# Issues for HPK Prototype Design

Tim Nelson - SLAC - 10/05/07

# Polysilicon Resistor Design

# HPK Proposal

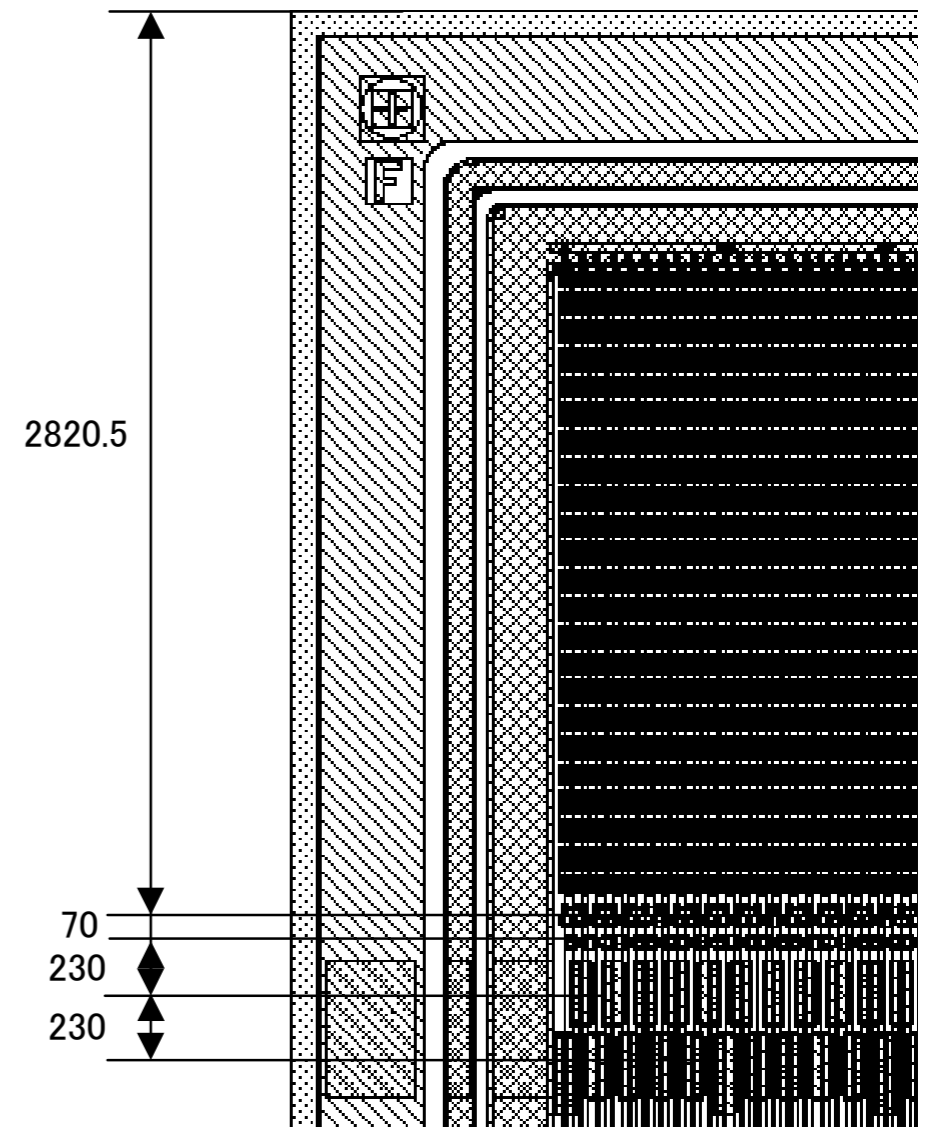
- ❏ 20-40 MΩ / 2.055 mm
- ❏ ~15 MΩ/mm
- ❏ Outer-row wirebonds for sensor-to-sensor connections will be 6.8mm: too long.
- ❏ This will be the case for any design with this pitch. Larger pitch alleviates the problem at the cost of single-hit resolution: maybe necessary for very long ladders.
- ❏ An adapter could be used for sensor-to-sensor bonds: adds significant complexity and the bonds will still be > 4mm.

PolySi patten length : 2055  
 PolySi resistance spec : 20-40MΩ

- ❏ Allow the change. I don't believe this is an acceptable configuration for long ladders, so I am against this approach.
- ❏ Cut the resistance in half. This would shrink the longest wirebonds for direct sensor-to-sensor connection to ~4.8mm. This may still be too long although perhaps possible based upon best processing we have seen.
- ❏ Cut the resistance to 10 ( $\pm 2?$ ) M $\Omega$  to achieve sensor-to-sensor bonds of ~4mm.
